2nd Draft **ISO/IEC JTC 1/SC 25/WG 3 N 764**

DOC TYPE: Liaison Report
TITLE: Draft liaison report to the IEEE 802.3at PoEP Task Group on power feeding via balanced channels
SOURCE: WG 3 Secretariat
(v. Pattay)
PROJECT: 25.03.02.xx: Generic cabling for customer premises
STATUS: Draft to be developed by correspondence as requested for by WG 3 at Edinburgh, UK, 2005-09-26/29 and subject to synchronisation with IEC SC 46C & SC 48B as requested by SC 25 plenary 2005-09-30.
1st Step the draft is sent to SC 25/WG 3 experts for comments (due to their meeting schedules IEEE 802.3at PoEP, IEC SC 46C & SC 48B are already included in this comment cycle with the request for input).
2nd step the completed draft is sent to IEC SC 46C & SC 48B with the request to include answers to the open questions and for endorsement/update of data on their products already included.
3rd step the liaison report is completed and forwarded to IEEE 802.3.
ACTION ID: FYI
DUE DATE: 2005-11-04

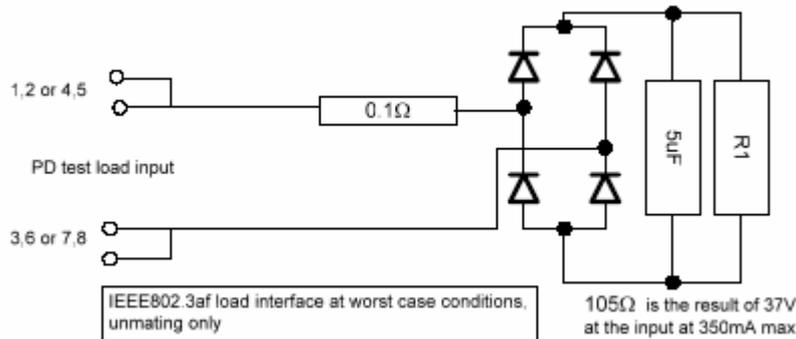
109 IEEE 802.3 needs to clarify the circuit components representing the load for un-plugging. So
110 far IEEE 802.3 indicates 0,420 A for the component calculation, though the actual current,
111 according to the sketch, over the common mode circuit of two pairs is 0,840 A. The
112 components representing the worst case capacitance and inductance of the channel will have
113 to be added to this circuit in determining the requirements for the test according to
114 IEC 60512-9-3.

164 IEEE Std 802.3af-2003 loads are not consistent with the circuit used to test connector mating
165 and unmating under load. Specifically, our devices ensure that:

- 166 • sources and loads are never active during mating, and,
- 167 • the load during unmating is as shown in the schematic below:

168
169 Given the load circuit above and an appropriate power source which powers the load only
170 after mating has completed, what would be the maximum load which may be repetitively
171 unplugged without performance degradation? Note that in the above circuit with $R1=105\Omega$
172 this would represent a 13 Watt load at 37 Vdc, which is the worst case for IEEE Std 802.3af-
173 2003; however, as stated earlier we are evaluating 51 Vdc and 420 mA per conductor which
174 would require $R1=60\Omega$.
